Environmental
Protection Agency

July 11, 2011

RE: TRUMBULL COUNTY
CITY OF NILES
NPDES PERMIT #OHC000003
OEPA PERMIT #3GC004982*AG
NILES MCKINLEY HIGH SCHOOL
CONSTRUCTION STORM WATER

Figure 1. Sediment is being tracked off site due to an inadequate construction entrance.

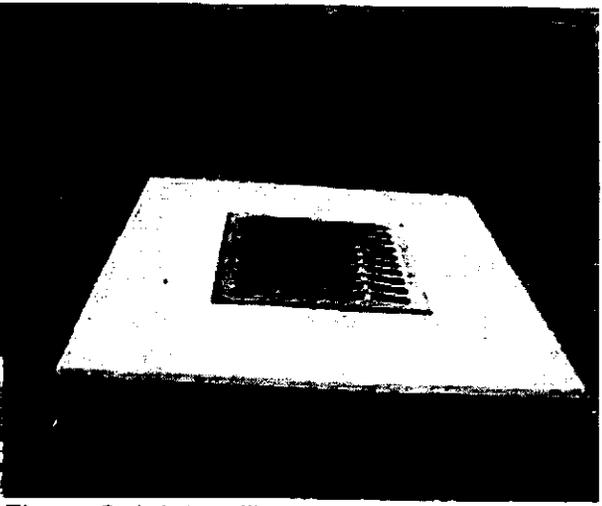
- Offsite tracking of sediment is occurring. A properly designed construction drive must be installed in accordance with the detail drawing depicted in the storm water pollution prevention plan (SWP3) on the North side of the site (Figure 1).

Figure 2. Inlets will soon be at final grade and require inlet protection.

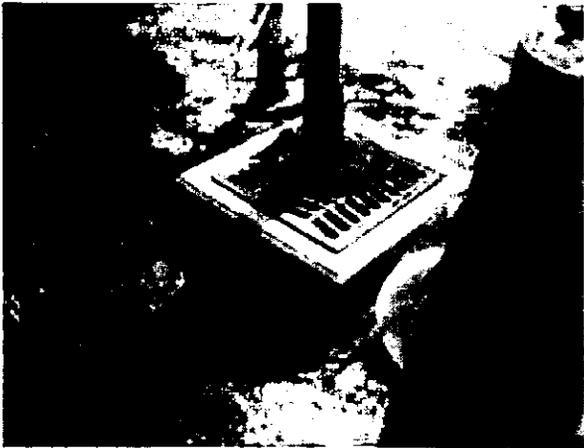
- There are several inlets throughout the site with no protection. Please install proper inlet protection as depicted in the *Ohio Rainwater and Land Development Manual* to prevent sediment laden water from discharging to surface waters of the State (See Figures 2 & 3).
